SERVICE BULLETIN

SUBJECT: DC Volt Analog Inputs, PIC II Controls

NUMBER: C0007

MODELS AFFECTED: 19XR, 23XL Chillers

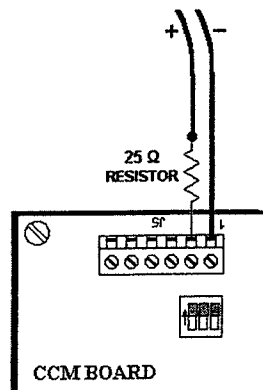
Experience has shown that when connected in the above fashion, the CCM reading of the input, converted to mA in the CVC tables, is 10% high. Options for adapting a 1 to 5 dc volt input to have the intended result (i.e., 5.0 dc volts = 20 mA) are:

- (1) Install a 25 ohm resistor in series with the + voltage lead(s) into terminal block J5. (The even numbered terminals are + here. As the CCM block is mounted in the control panel, the numbering is upside down with terminal 1 on the right side.) The DIP switches should remain in the ON (up) position. See the example in the sketch below.
